Georgetown Charter Township

Planning Commission Meeting Agenda

7.I. (PUD2003) Wesco Inc. (36th Ave./Baldwin PUD), Is Requesting Preliminary (For This Parcel Only Since The Preliminary Approval Has Expired And The Rest Of The Site Has Already Been Developed) And Final Planned Unit Development Approval For A Vehicle Service Station And Convenience Store On P.P. # 70-14-17-100-024, Located At 7661 36th Ave., Georgetown Township, Ottawa County, Michigan.

7.I.ii. (PUD) Wesco Staff Report

TOPOGRAPHIC / BOUNDARY SURVEY

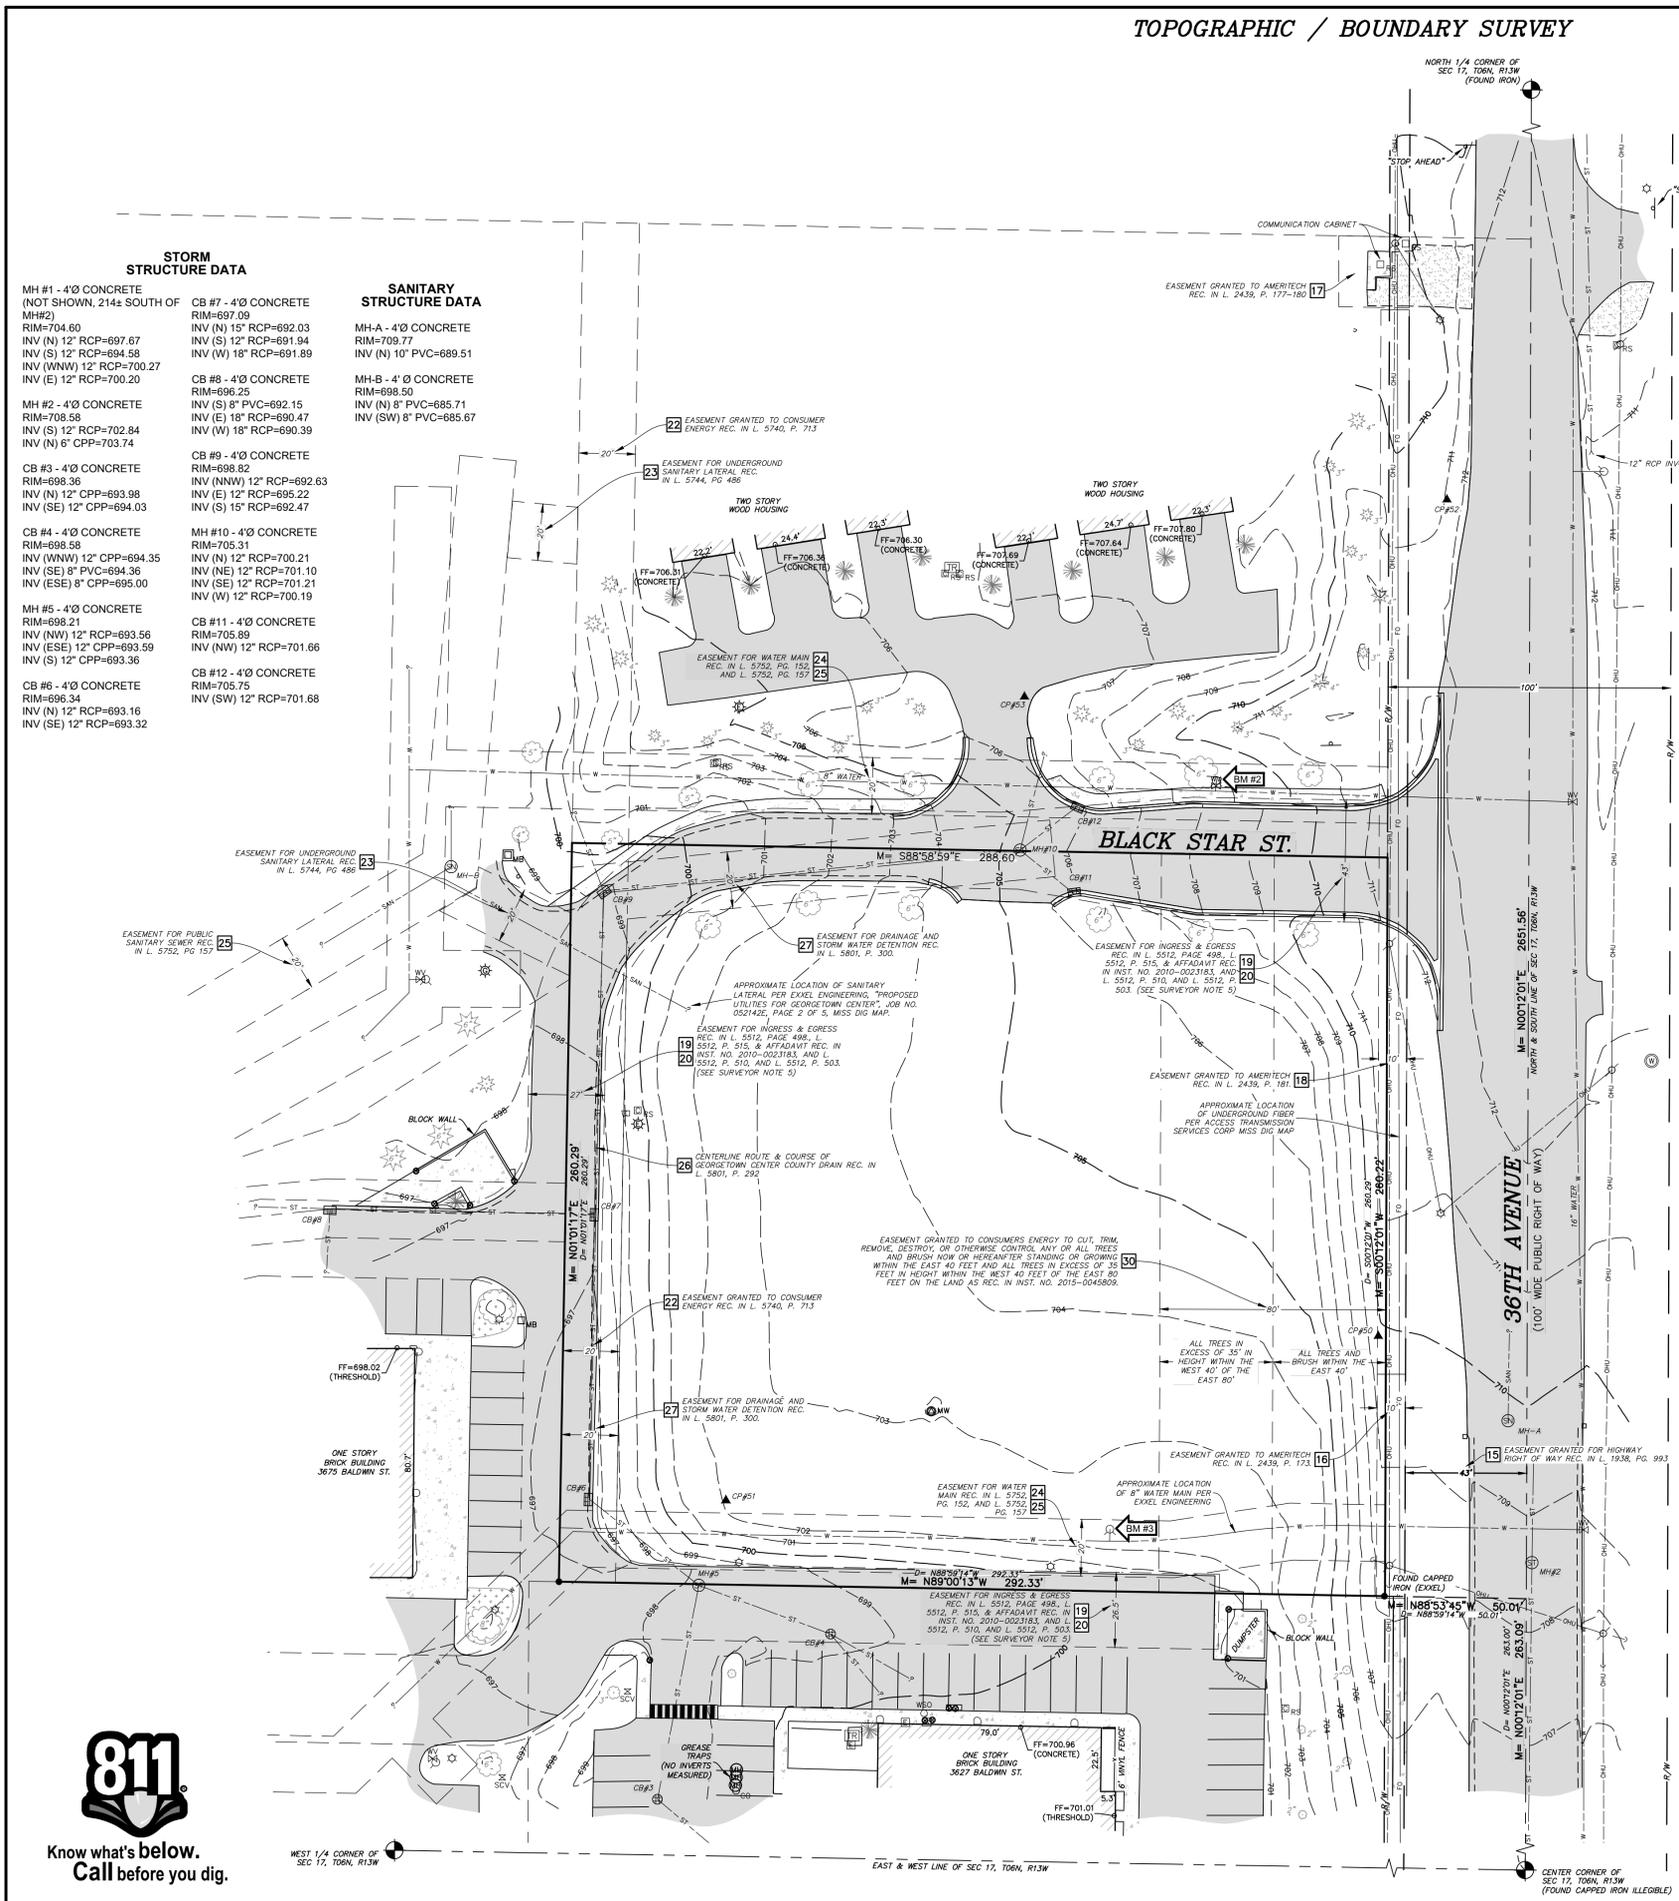
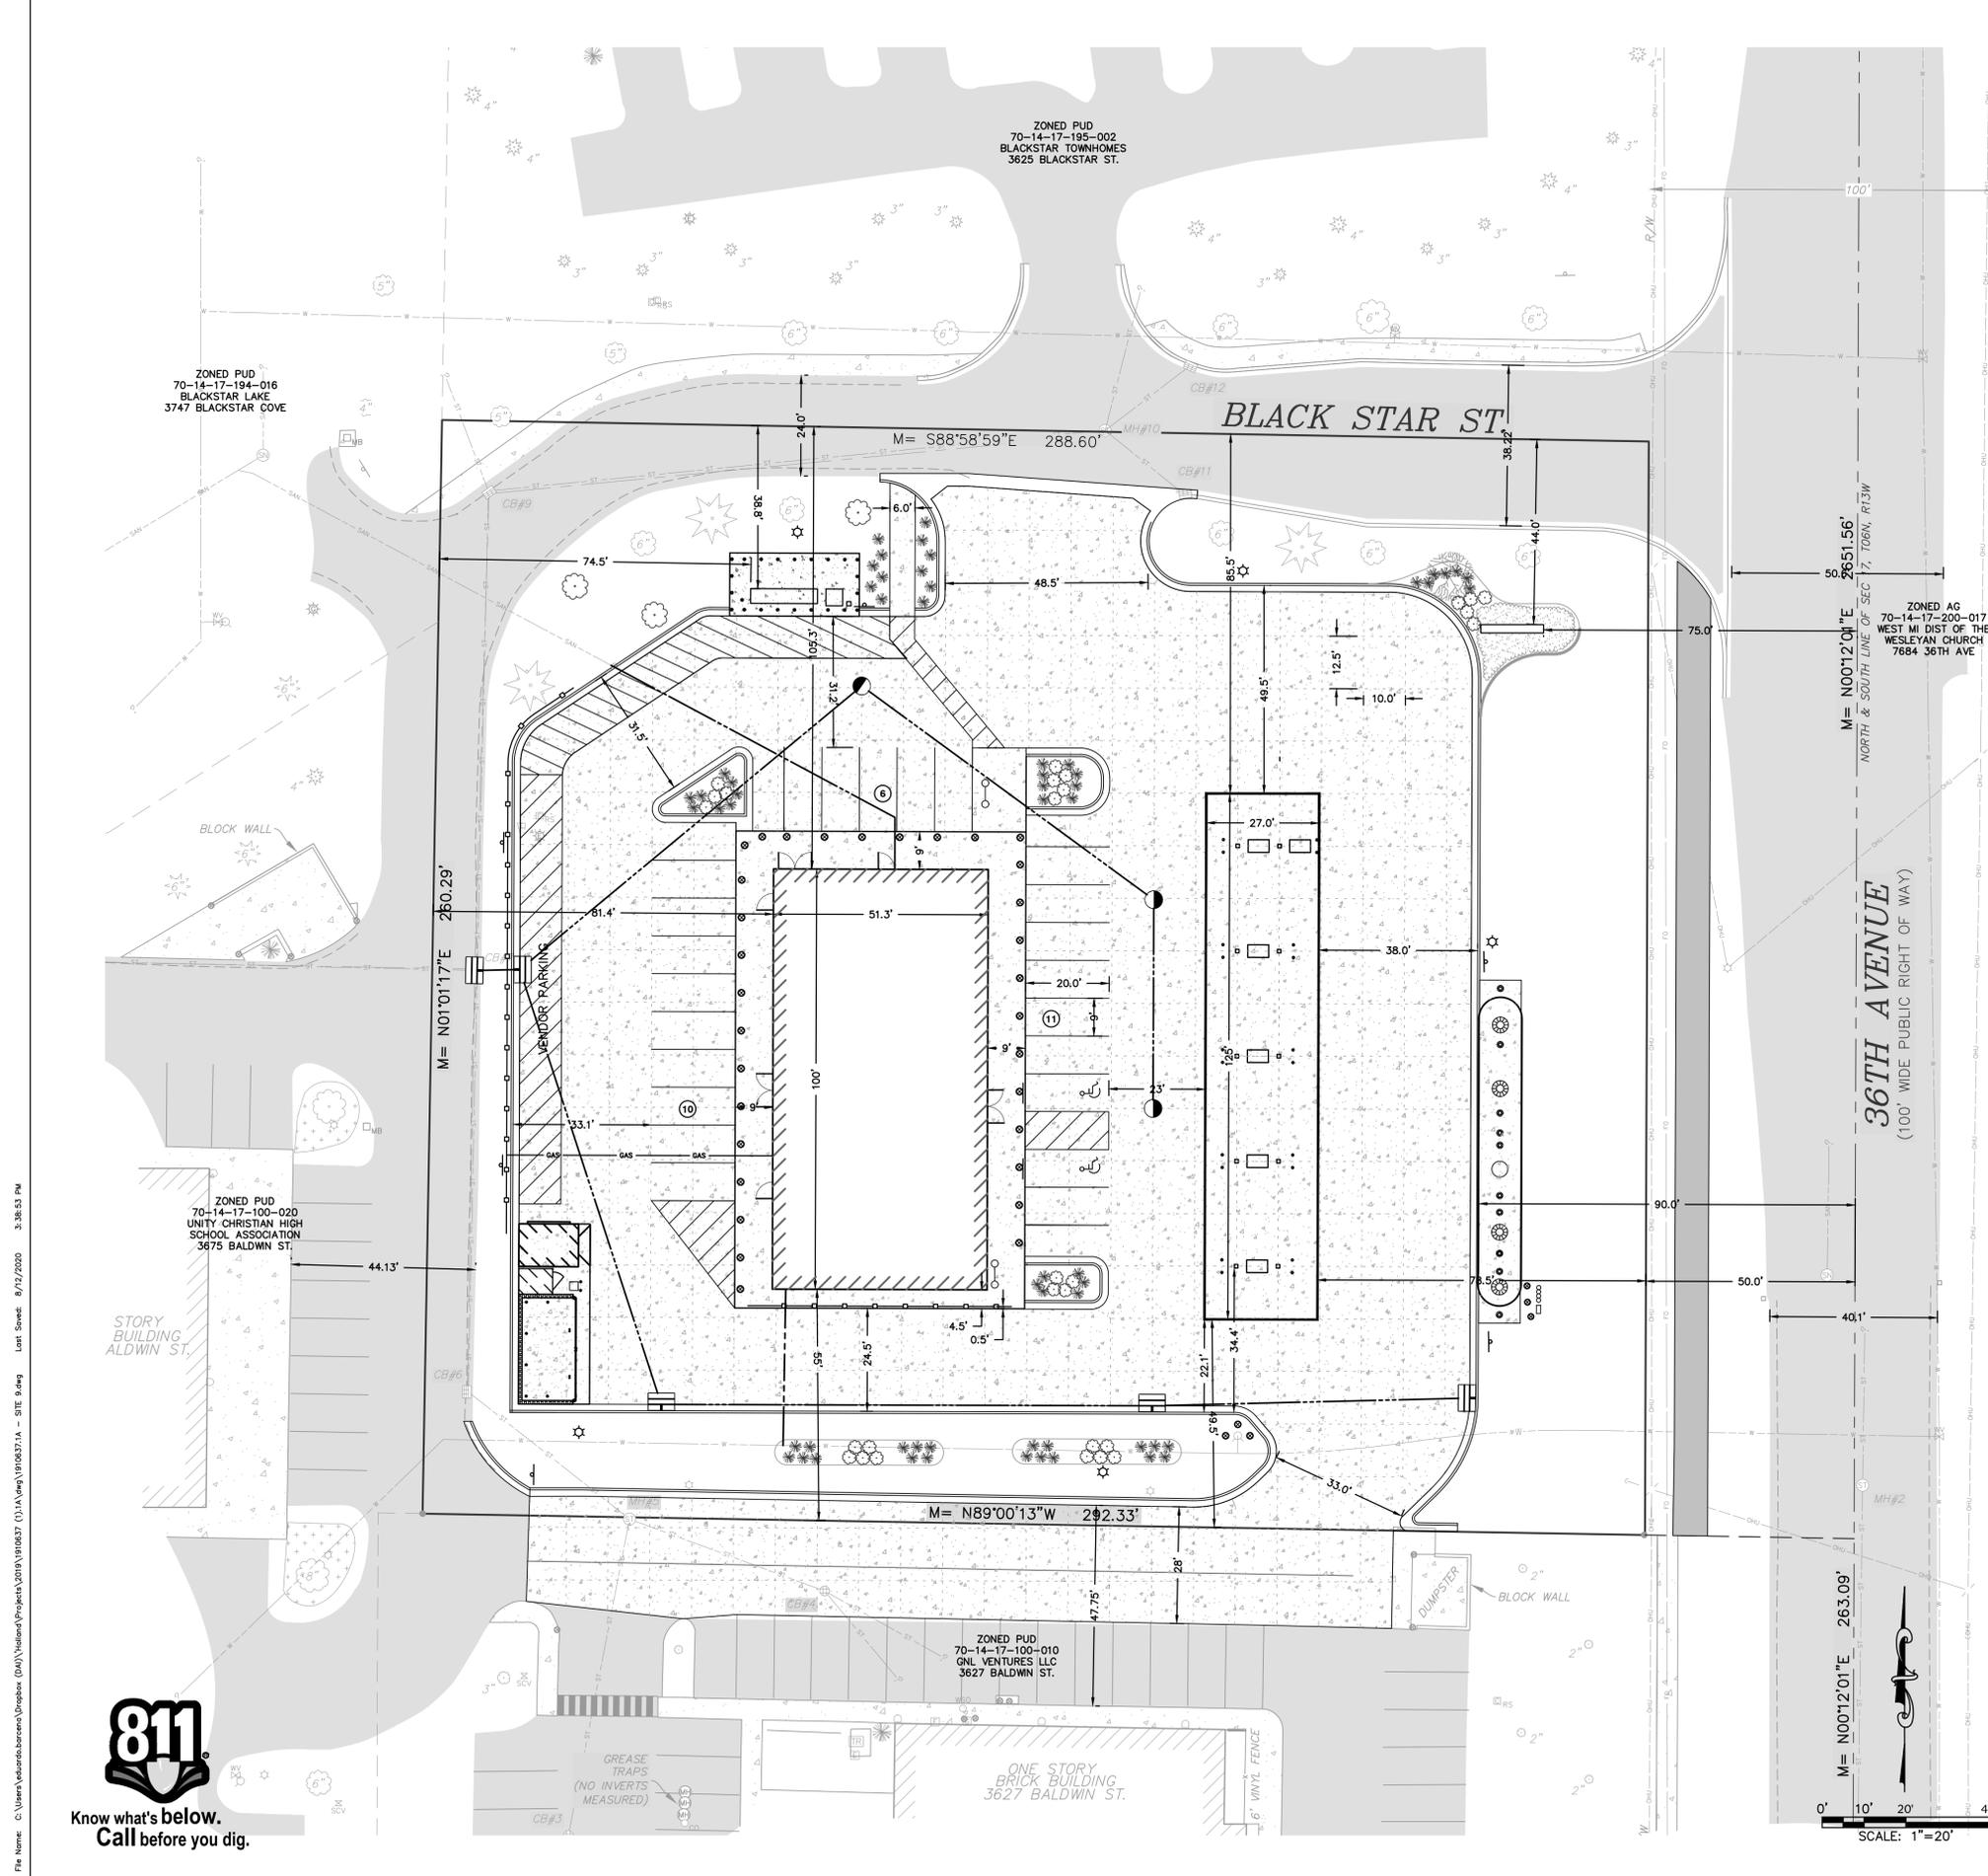
However, as noted on sheet V-101, there is an easement along 36th Ave. that prevents trees from being placed in the front setback, which are needed to meet streetscape requirements. The applicant has indicated that they are investigating having the easement vacated to allow the trees for the streetscape to be planted in the front setback area of 36th Ave.

- d. The location, type and size of all proposed landscaping and site amenities (art work, fences, gateway features, etc.). **PROVIDED. However, it is noted on sheet V-101 that an easement prevents trees from being planted in the front yard setback on 36th Ave. A recommendation is to approve sheet L-101B which shows the required trees along 36th Ave., and to stipulate that if the required number of trees cannot be placed in the front yard setback on 36th Ave., they would be required to be placed elsewhere on the site.**

A suggestion would be to approve the landscape plan shown on sheet L-101B and then if they are not allowed to plant the trees in the front setback area of 36th Ave., the same number of trees (size, etc.) could be required to be planted elsewhere on the site.

LANDSCAPE PLAN

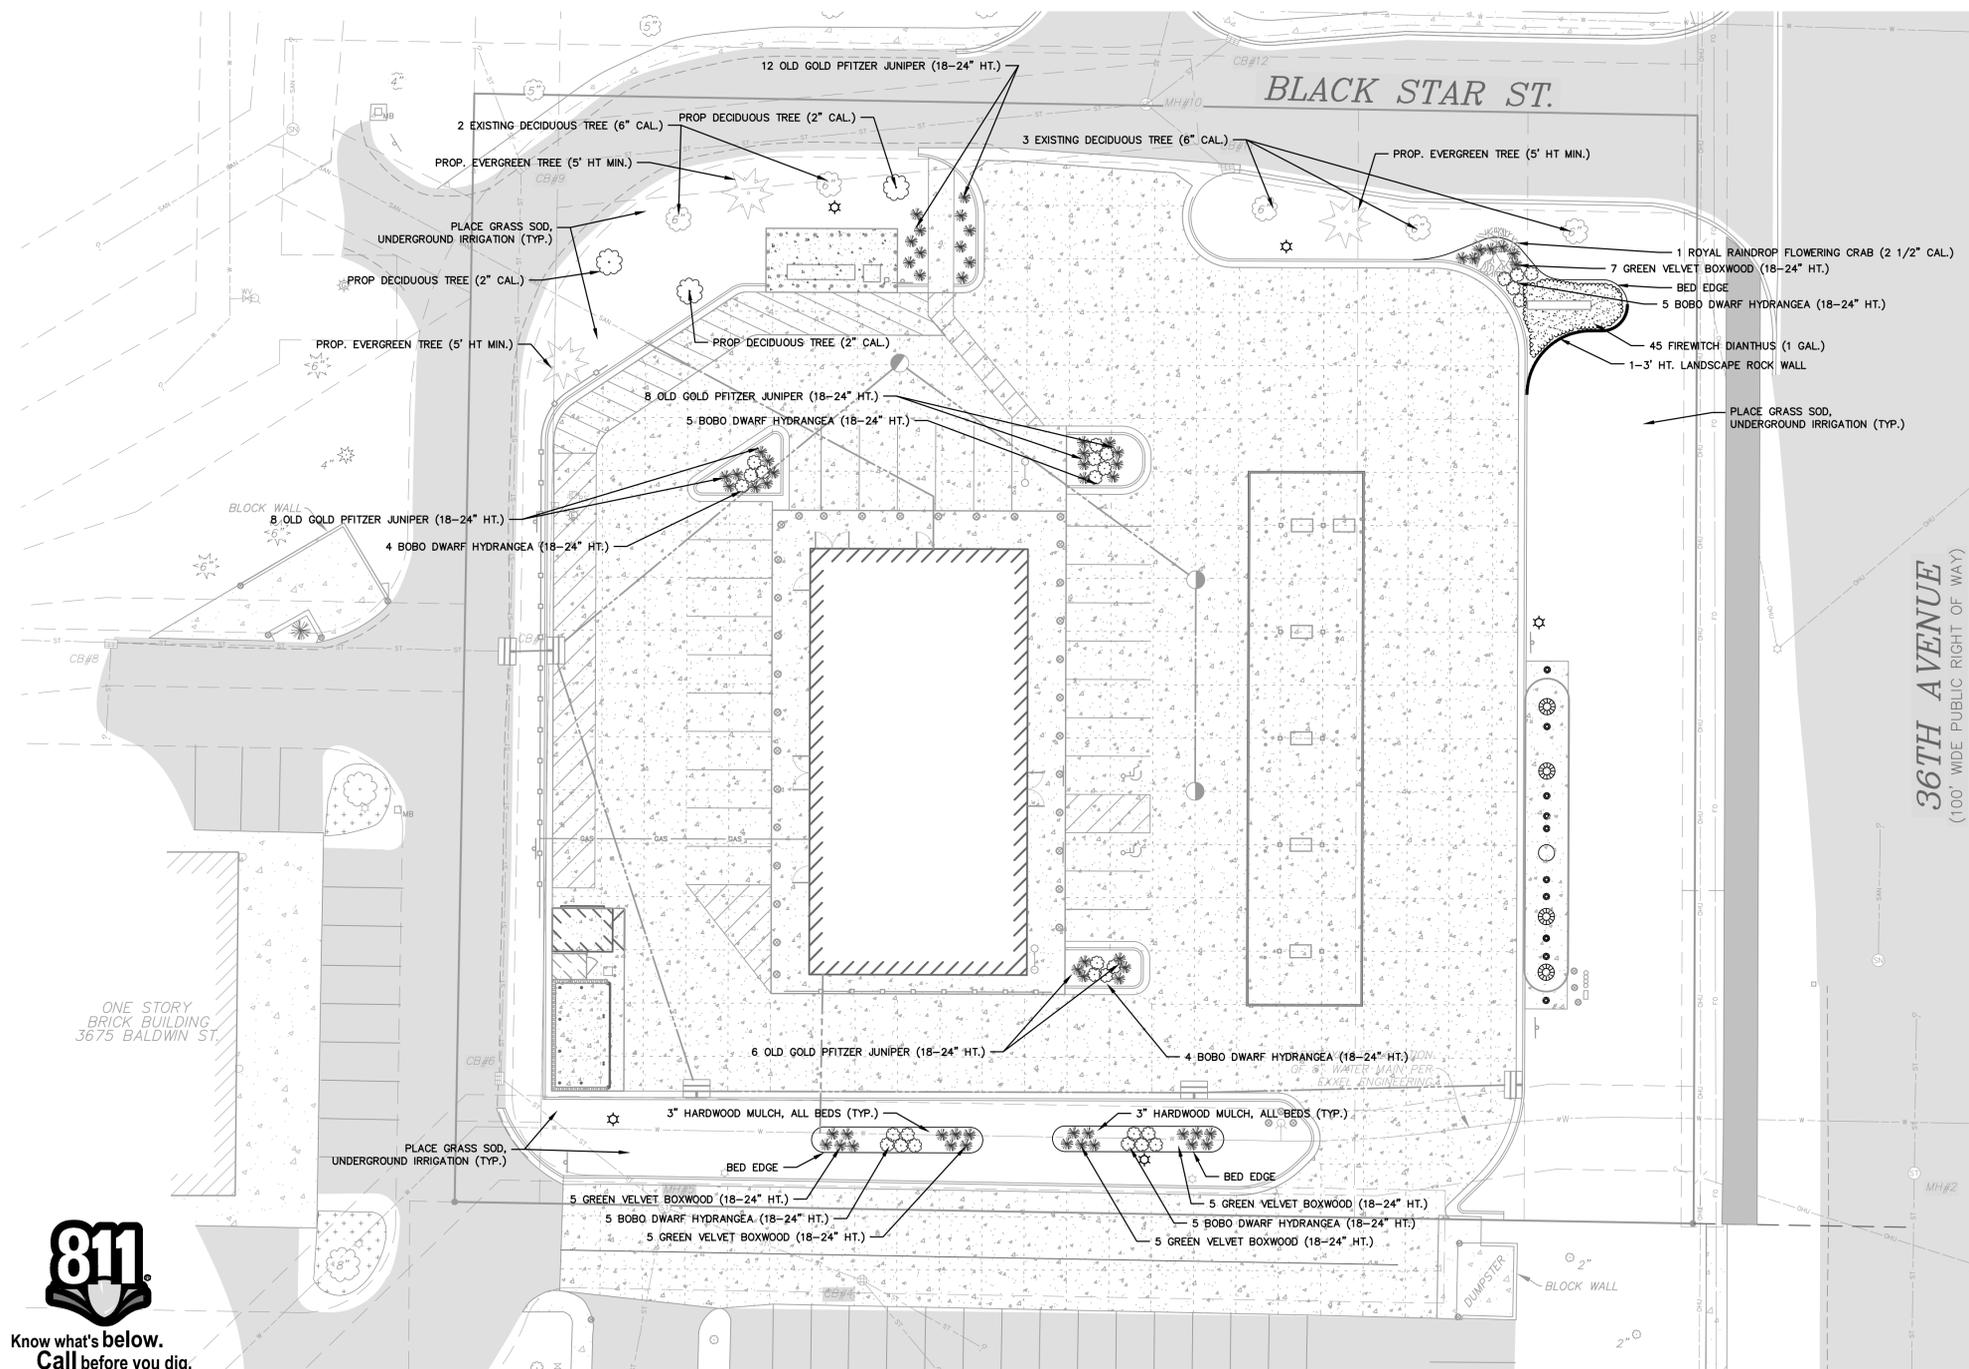
- c. Are the two deviations for the ground mounted sign acceptable?
- d. **Should the landscape plan shown on sheet L-101B be approved with the contingent plan that if the easement is not vacated and trees are not allowed to be planted in the front setback area of 36th Ave., the same number of trees (size, etc.) shall be required to be planted elsewhere on the site?**
